Re: Caterpillar Clubhouse
803 2nd St. SW
Traffic Circulation Layout
Architect's Stamp 04-01-22 (K14-D227)

DRAINAGE AND TRANSPORTATION INFORMATION SHEET (REV 3/2018)

TRAFFIC CIRCULATION LAYOUT

1. REMOVE AND DISPOSE OF CURB AND GUTTER.
2. REMOVE AND DISPOSE OF CONCRETE CURB RAMP.
3. REMOVE AND DISPOSE OF CONCRETE SIDEWALK OR DRIVEWAY.
4. REMOVE AND DISPOSE OF PORTION OF CONCRETE DRIVEPAD.

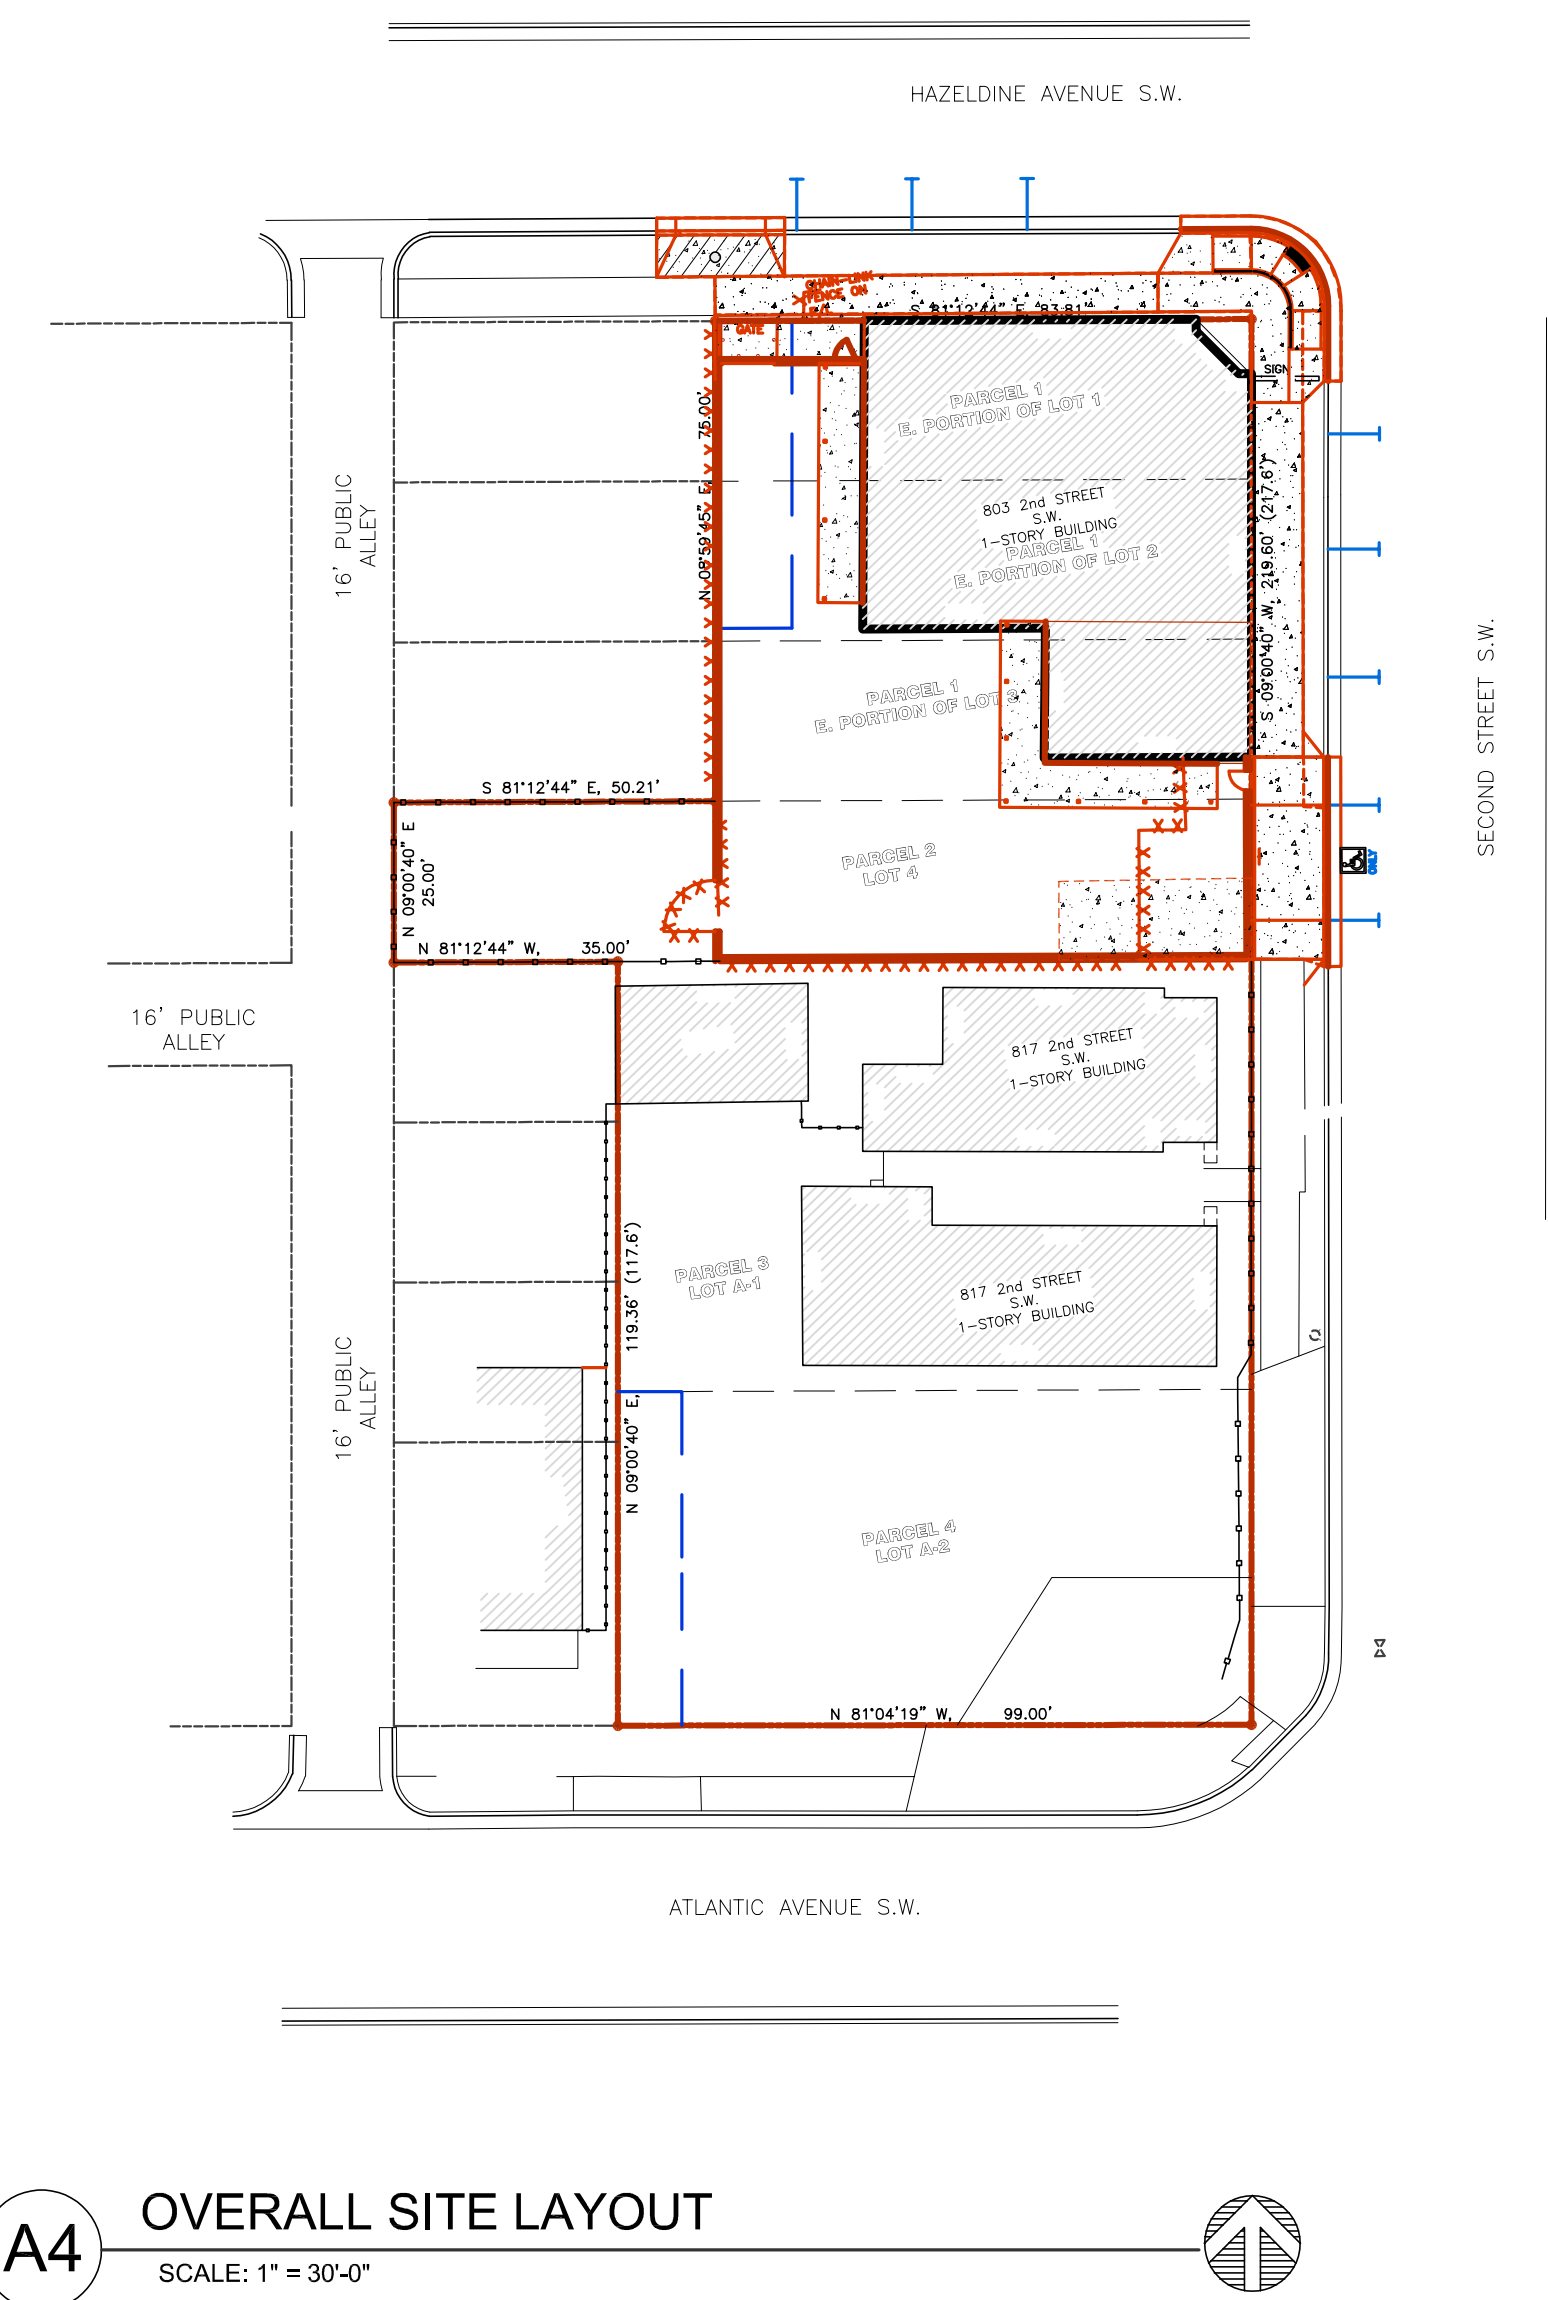
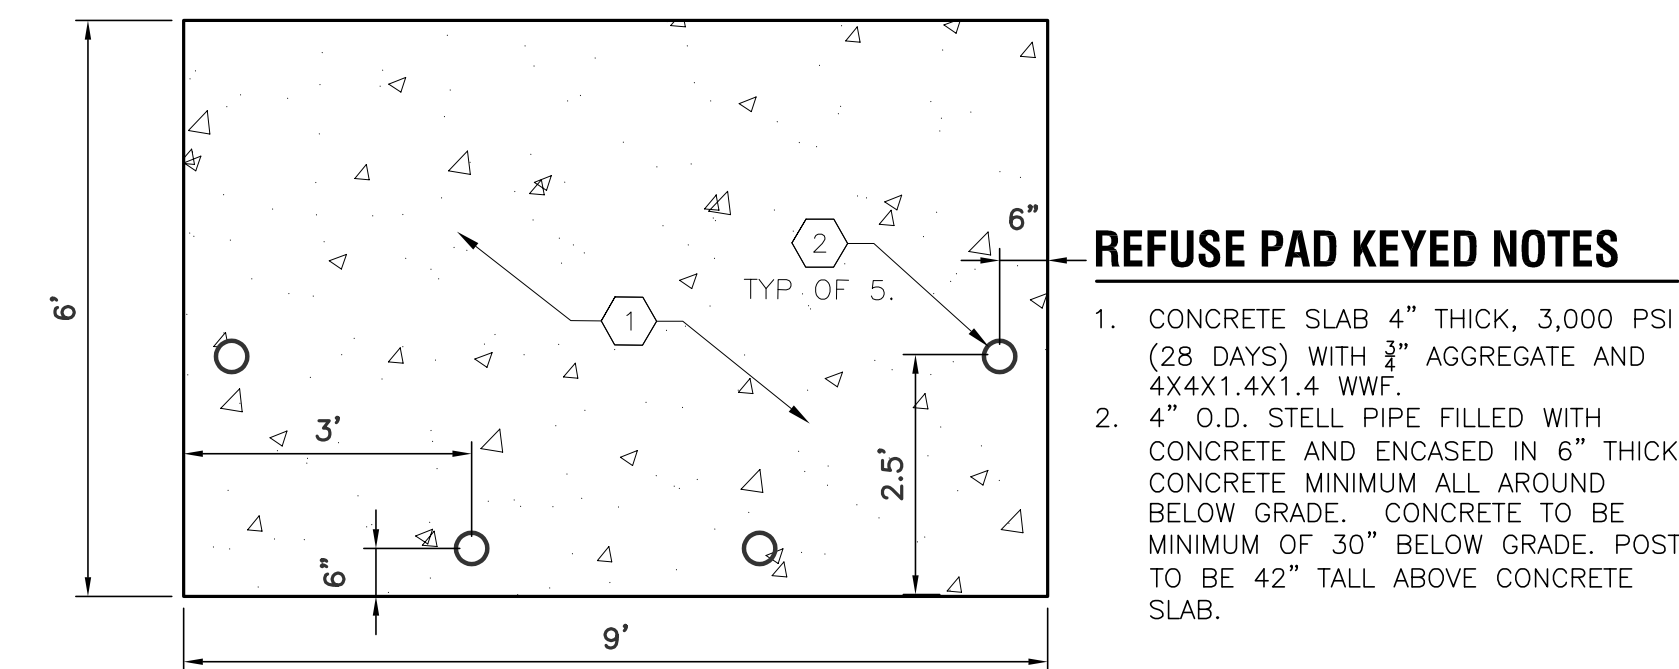
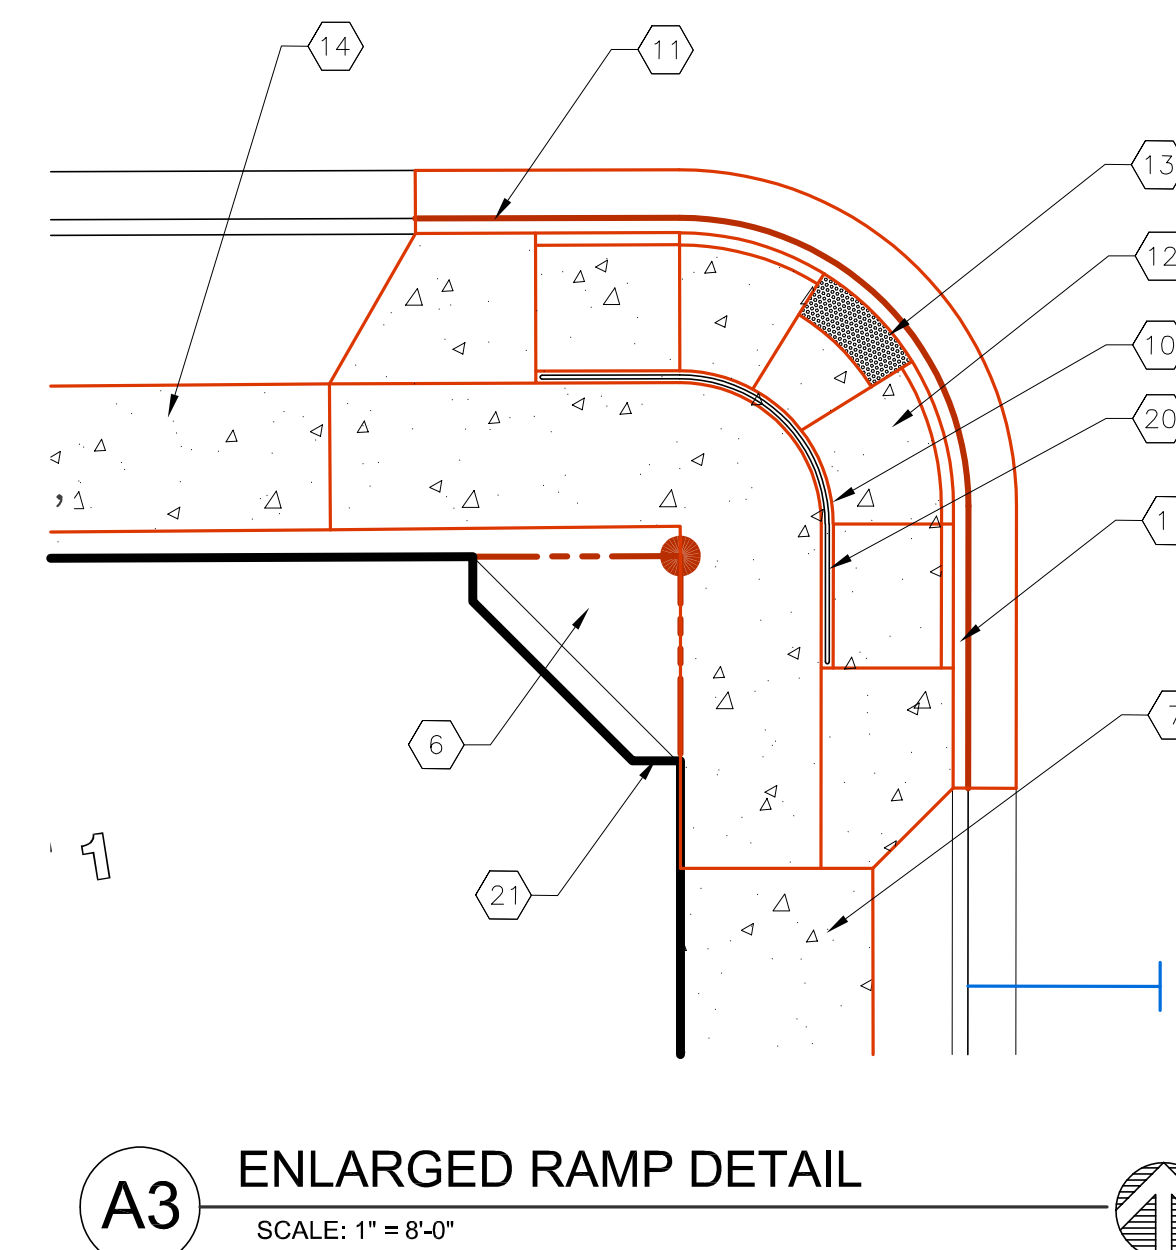
1. List the number of parking spaces required by the IDO as well as the proposed number of parking spaces including bicycle and motorcycle parking.
2. Provide Approved Plat showing the blanket access easement across all these lots for access.

3. ADA parking stall is not permitted on Public Right of Way Per City Engineer.
4. Handrail is not permitted on Public Right of Way Per City Engineer.
5. Call out COA std dwg for the Driveway off 2nd st.

6. Provide the dimension from the on street parking stall to the intersection of 2nd st. and Hazeldine Ave. show this dimension on site plan.
7. On-street parking spaces need to be 20' long.

8. Show the intersection sight distance for the driveway entrance off 2nd St. and add the following note to the plan: "Landscaping and signage will not interfere with clear sight requirements. Therefore, signs, walls, trees, and shrubbery between 3 and 8 feet tall (as measured from the gutter pan) will not be acceptable in the clear sight triangle

9. Show the clear sight triangle for the driveway entrance off Hazeldine Ave. and add the following note to the plan: "Landscaping and signage will not interfere with clear sight requirements. Therefore, signs, walls, trees, and shrubbery between 3 and 8 feet tall (as measured from the gutter pan) will not be acceptable in the clear sight triangle

1. A Zone Atlas Page will be added to the plan to provide the vicinity map.
2. We will coordinate with Zoning on the parking counts. Please note that we do not have any off-street parking provided and Sections 5-5(D)(1) and 5-5(E)(1) call for bicycle parking based on Off-Street parking provided.

3.
 - a. On the prior submittal, the driveway was designed to replace an existing driveway that was degraded. At this time, the access easement that was held by the adjacent property to allow access through the project site, has been vacated. The neighbor has a gate and access to a parking space on the west side of the existing driveway. We can either leave the old driveway there or replace it with our project. We could also widen the driveway to allow for a COA compliant width driveway along the project parcel street frontage.

- b. Plans currently call for KN #9 that requires the concrete drive pad to be built per COA Std Dwgs 2425a and 2425B. Please refer to the enlargement on sheet TCL-2.

- c. Handrails have been proposed because to meet ADA the curb access ramp needs to have sloping sections going west and south from the landing. Also the access door to the building is located very close to this corner and to prevent the public from accidentally stepping off the curb, we feel it would be best to include a simple railing.

- d. On-street parking does meet the DPM that requires that end stalls be 18' long and intermediate stalls be 20' long, both 8' wide for parallel parking. Please see the dimensions on A1/TCL.

- e. The sidewalks around the site are in poor shape. The plans call for public sidewalks along the project frontage to be removed and replaced per COA Std Dwg 2430. Please see plans and KN's #3 and #14. There was a KN #7 that was incorrect on the plan on the 2nd Street side. This has been corrected.

- f. ADA Parking Stalls
 - i. The plans call for a drivepad to ensure that what seems to be sidewalk is built thick enough to allow for vehicular traffic without cracking over time. We are not proposing any on-site parking, just parallel. The sidewalk will be over 8' wide to allow for Van accessible ADA parking/unloading in this area.

- ii. The drivepad is to be thick like 2425 A & B, but to have the sloping sidewalk connections like 2443. This particular location will be a combination of both.

- iii. The header curb is to allow for the 6" grade difference between the bottom landing and the sidewalk that must meet up with grades at the entrance door into the facility. The access door to the building is located very close to this corner and to prevent public from accidentally stepping off the curb, we feel it would be best to include a simple railing.

- iv. A short taper on the sidewalk will be added to help guide the visually impaired in the section of ADA unloading zone on 2nd Street.
- 4. The unloading zone for the Van Accessible parking stall is the adjacent sidewalk. The sidewalk is shown over 8' wide to comply with Van accessibility requirements.

- 5. The Van Accessible parallel parking includes an unloading zone on the sidewalk. There is no striped area that would receive the "NO PARKING" letters.

- 6. Please note that we do not have any off-street parking provided and Section 5-5(D)(1) calls for motorcycle parking based on Off-Street parking provided. We have no off-street parking provided.

- 13. Clear Sight applies when we have driveways into the project site.
- 14. Parking is held back over 30' at the Hazeldine/2nd intersection.
- 15. On the prior submittal, the driveway was designed to replace an existing driveway that was degraded. At this time, the access easement that was held by the adjacent property to allow access through the project site, has been vacated. The neighbor has a gate and access to a parking space on the west side of the existing driveway. We can either leave the old driveway there or replace it with our project. We could also widen the driveway to allow for a COA compliant width driveway along the project parcel street frontage.
